UNITED STATES
NUCLEAR REGULATORY COMMISSION

SUBJECT: TURKEY POINT NUCLEAR PLANT - NRC INSPECTION REPORT
05000250/2006015; PRELIMINARY WHITE FINDING

IR 05000250/2006-015; 08/06/2006 - 08/17/2006; Turkey Point Nuclear Power Plant, Unit 3; Other Activities.

Turkey Point
3A 4160 Volt Bus (Simplified)

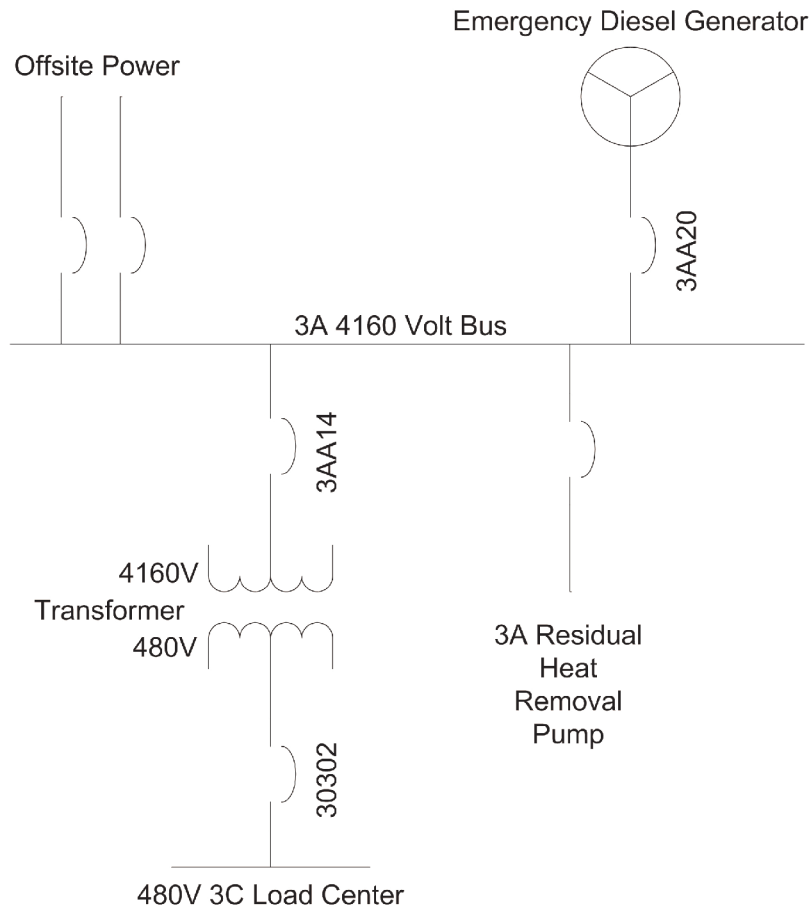
Description: On March 8, 2006, following the early completion of electrical bus maintenance, the licensee initiated an electrical restoration to the 3C 480 volt load center from the A 4160 volt safety bus (See figure below).

The 480 volt supply breaker to the 3C Load Center (breaker 30302) had been replaced (like for like) with a refurbished breaker, and unknown to the operators, the auxiliary switch of the breaker was installed such that the breaker open contact was "off" with the breaker shut and "on" with the breaker open, while the opposite was desired. The auxiliary contact made up logic for the 3A bus sequencer which used 3C load center

voltage and breaker (30302) position as an indication of proper electrical status of the safety busses. After breaker 30302 was installed (in the open position), the operator shut 4160 volt breaker 3AA14, "3C Load Center Feed from 3A 4160 Volt Bus" (See Figure). The 3C Load Center remained de-energized, as intended, but because of the reversed auxiliary contacts, the lineup made up sequencer logic that the 3C load center power supply breakers were both shut (while breaker 30302 remained open) and the load center had no voltage, which initiated a sequencer load shed of the 3A 4160 volt bus. The load shed stopped the running A RHR pump, which resulted in a loss of decay heat removal. The sequencer started the 3A emergency diesel generator and re-energized the bus. As expected the A train intake cooling water pump and A train component cooling water pump (both part of the decay heat removal train) were sequenced on. The RHR pump was not restarted and operators entered 3-ONOP-004.12, "Loss of 3A 4KV Bus While on Backfeed", which assured proper electrical sequencing. Had proper sequencing not taken place, the procedure would have directed actions to restore power to the 3A bus. Because the sequencer had worked properly, 3-ONOP-004.12 directed transition to 3-ONOP-004.10, "Loss of Offsite Power While on Backfeed", which assured proper starting and loading of the diesel generator. Because decay heat removal had stopped, 3-ONOP-004.10 directed the operators to 3-ONOP-050, "Loss of RHR", which was used to restore decay heat removal. During the loss of cooling, the coolant system temperature increased from an estimated 113 degrees F to 140 degrees F.
